**PURPOSE**

There has been a change in the supplier of the start capacitor used on Single Phase PC3 units, implemented to help reduce overall cost to customers. As a result of this change, the new capacitor differs in physical size and can no longer be mounted to the motherboard in the same manner as the previous version. This change required a new part number to be assigned to the updated capacitor.

5220 MOTHERBOARD ASSY;1PH

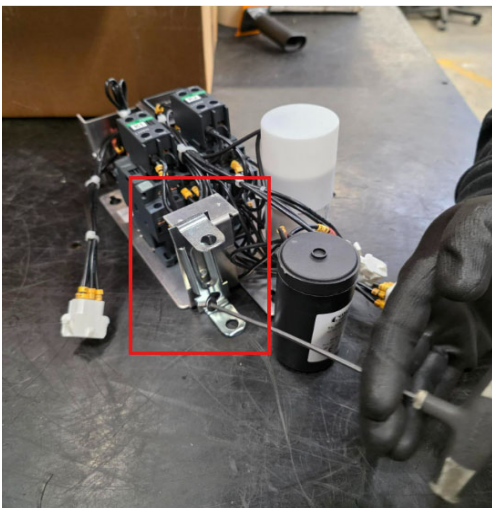
Due to a significant size difference between the legacy capacitor (P/N 5882) and the updated capacitor (P/N 726182-1), a minor modification is required to ensure proper fitment. When replacing P/N 5882 with P/N 726182-1, the new capacitor must be installed in the existing location and securely fastened to the motherboard bracket using an approved securing method. Refer to the procedure below for detailed installation instructions.

1 ea	726182-1	CAPACITOR;START;130-156mF;330V
1 ea	5851	CABLE TIE;PANDUIT #PLT-3S-MO

1 ea	T-Handle	Size 4mm
------	----------	----------
